December 14, 2023 – 6:00 pm Village Hall 235 Hickory Street, Pewaukee, WI 53072

STAFF REPORT

Village of Pewaukee Plan Commission Engineer's Report for December 14, 2023

OF 7

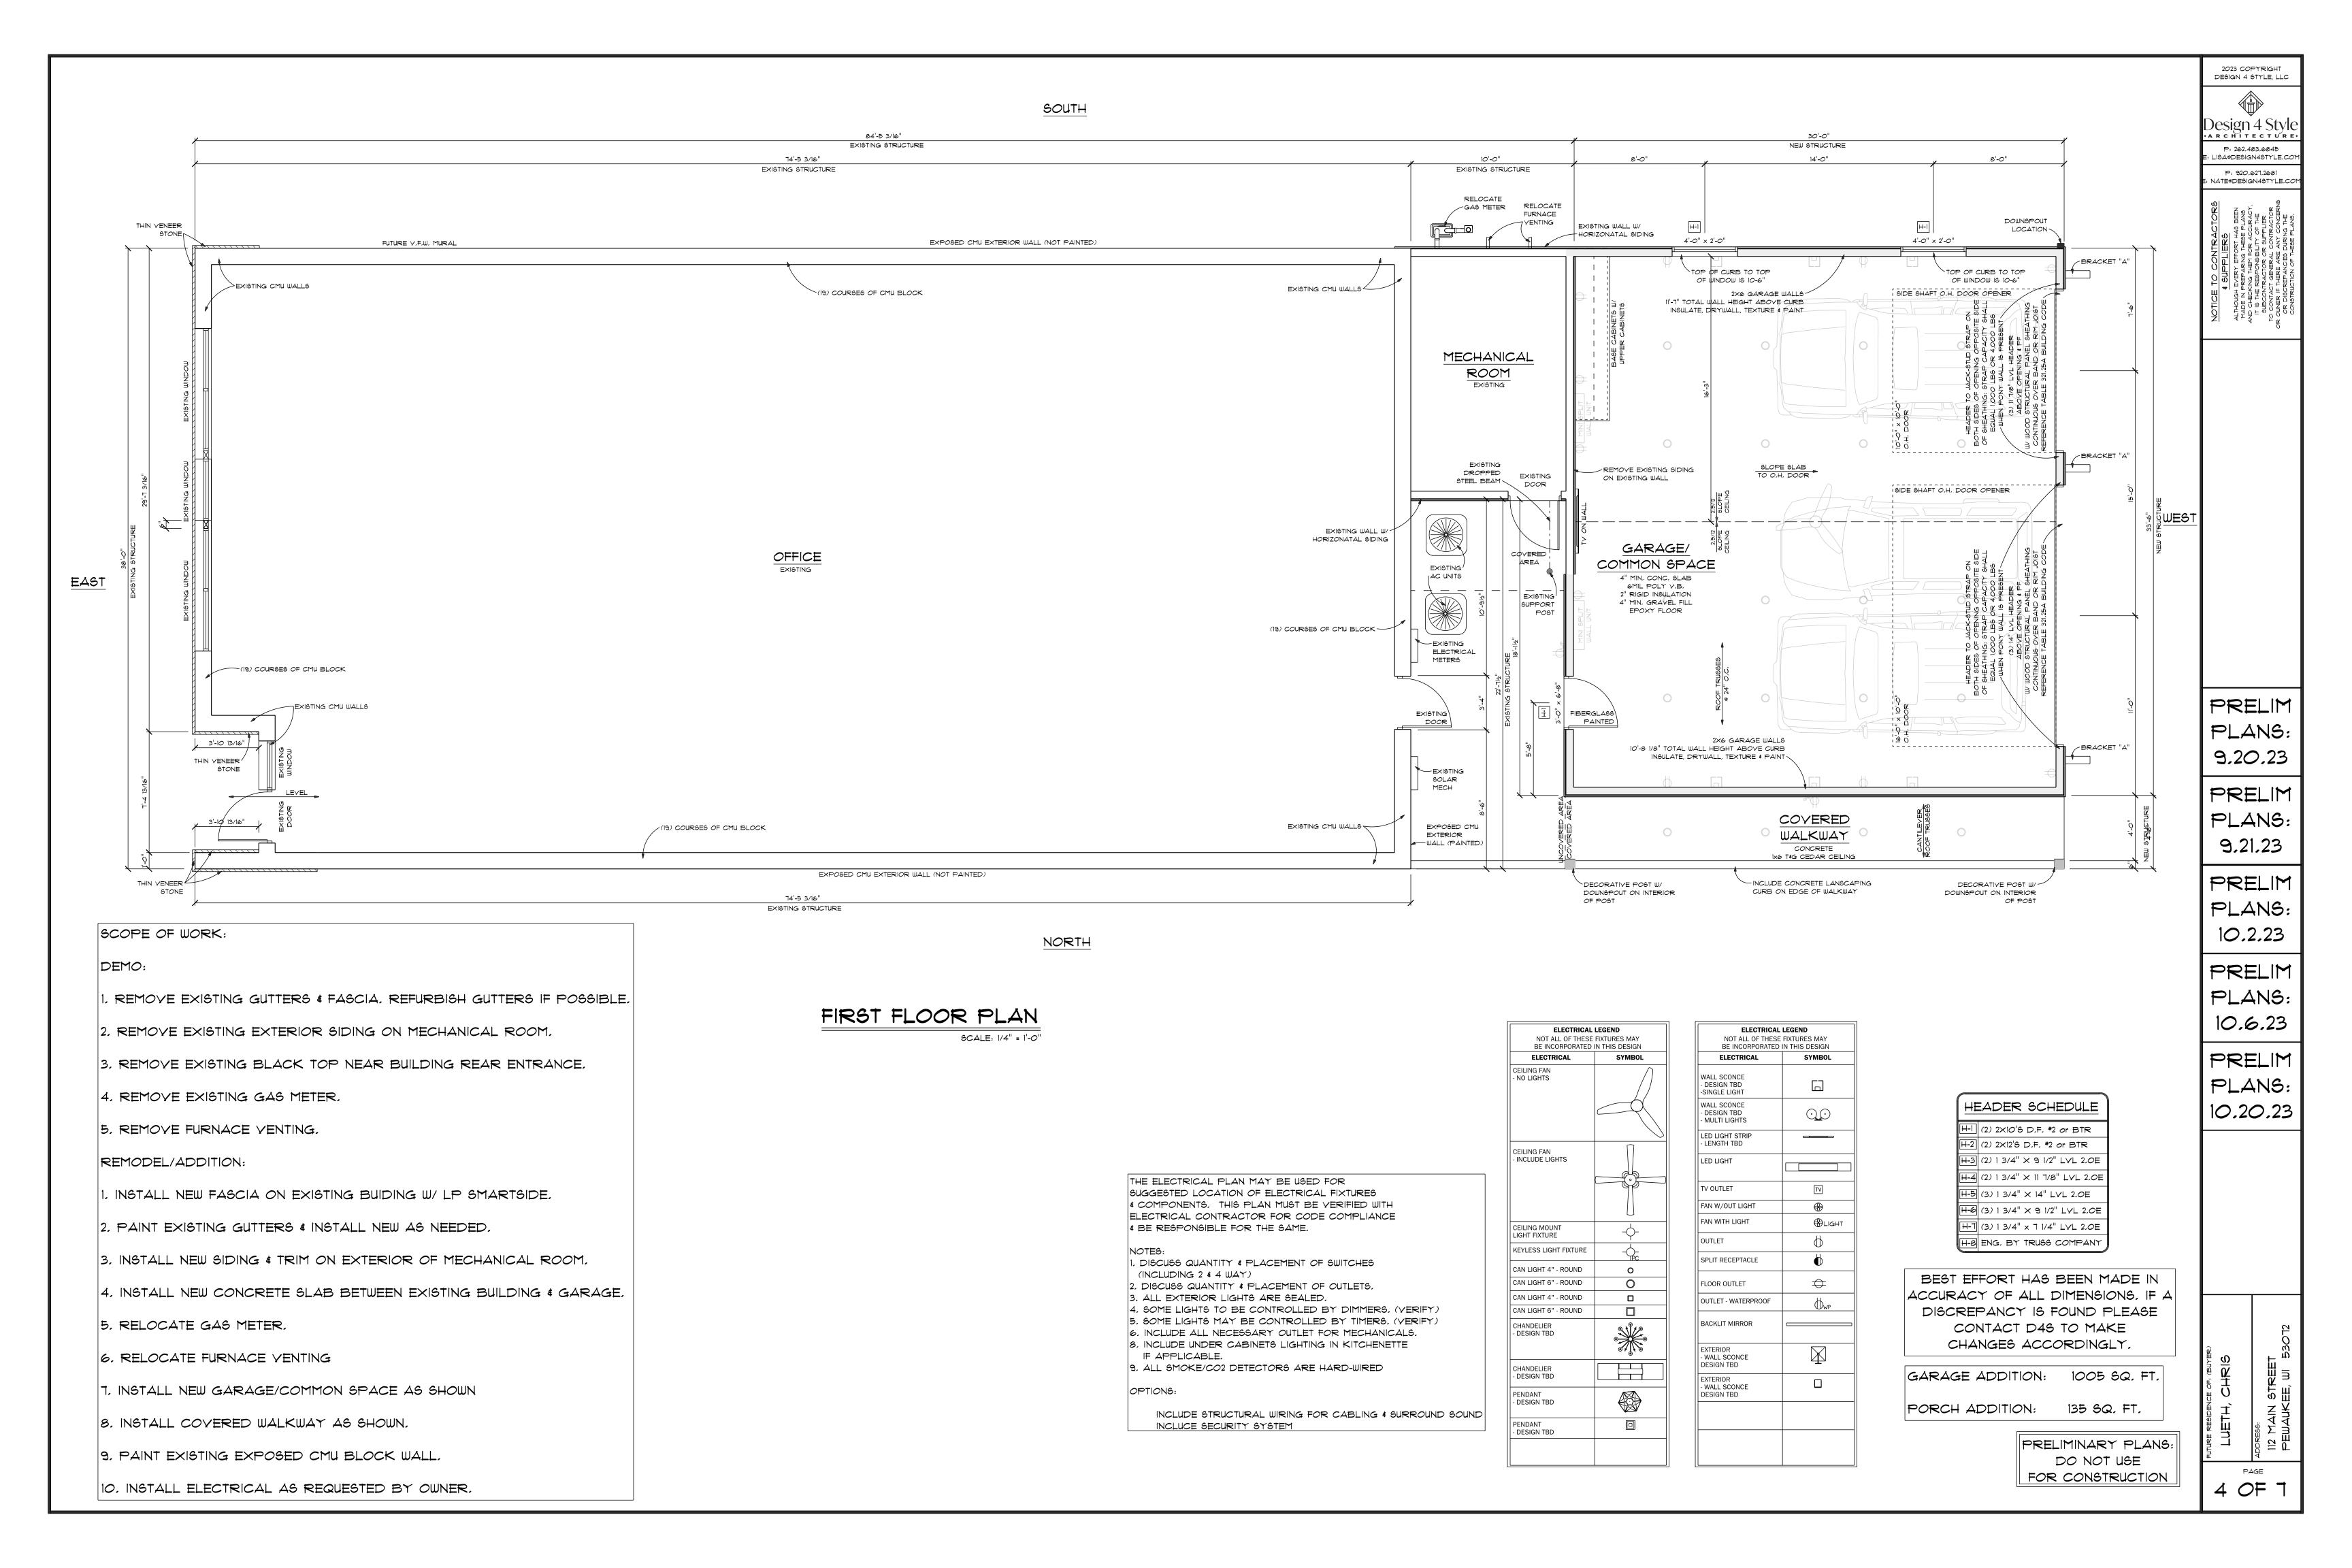
As recently revised, this plan places the addition approximately 2-feet off the south lot line so there is room for the standard soffit overhang and gutter without crossing over property boundaries. As a B-2 district use(s) and/or development on a lot less than 7,000 square feet in size, this is a conditional use. Furthermore, buildings greater than 5,000 square feet in the B-2 District may only be approved through conditional use grant.

Required side yard offset for the B-2 District is 10-feet. The proposed garage addition will not meet this requirement as to sideyards. Waiver or modification of this requirement can be approved by the Planning Commission through conditional use.

The owner is requesting to construct a new garage west of his existing building on Main Street. The building will be placed in a location where there is existing asphalt. Three existing public parking spaces in the parking lot will be removed to construct the garage. The garage will be available for three vehicles according to the submitted plans.

- The owner install gutters and downspouts on both the north and south sides of the roof and discharge the water onto the applicant's property in order to maintain the current runoff pattern.
- The owner provide proof of access permission from adjacent property owners north and south
 of the subject property since the building is on or close to the property line and he will need
 access for equipment and personnel to construct the building.
- Consideration and resolution of any comments heard at the public hearing.

PLAT OF SURVEY

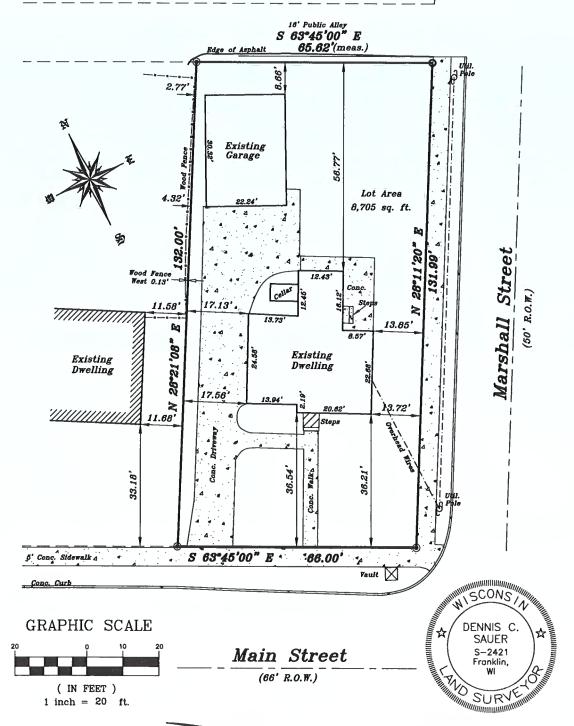
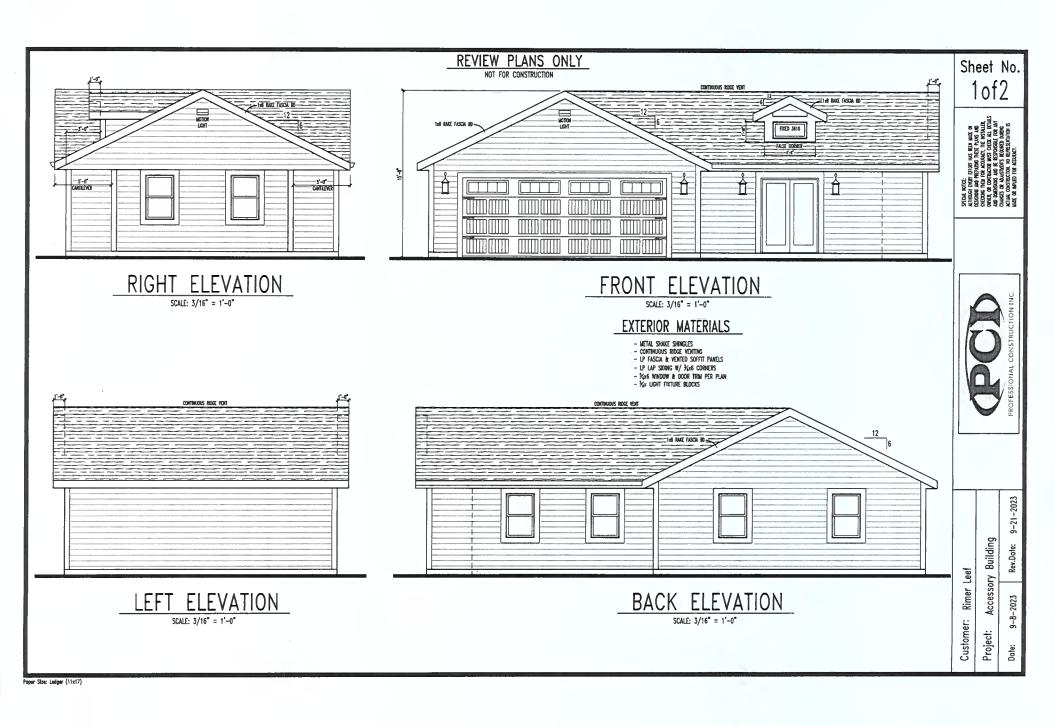
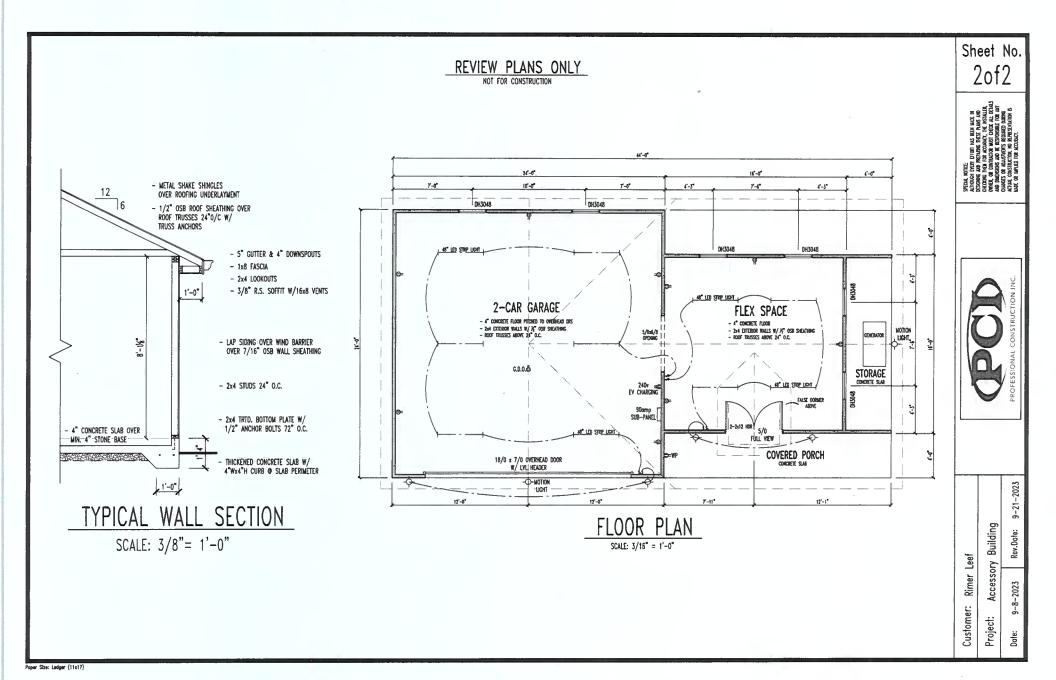
The applicant proposes to construct a replacement detached garage. It will be larger than the existing detached garage. It will be placed at a 9-foot setback from the alley and a 16.61-foot setback from Marshall Street. In the R-5 District, a 35-foot setback from the public right of way is required unless waived or modified by action of the Planning Commission through Conditional Use grant approval.

The existing garage is located on a flat portion of the property, with drainage that flows to the east and north. The proposed garage appears to be such that the existing drainage pattern would remain the same. The existing garage collects water from the roof in gutters and downspouts on the north side of the garage and directs the water north to an existing alley. Water along the west side of the existing garage flows to the west. The proposed plans do not show gutters and downspouts or lot grades.
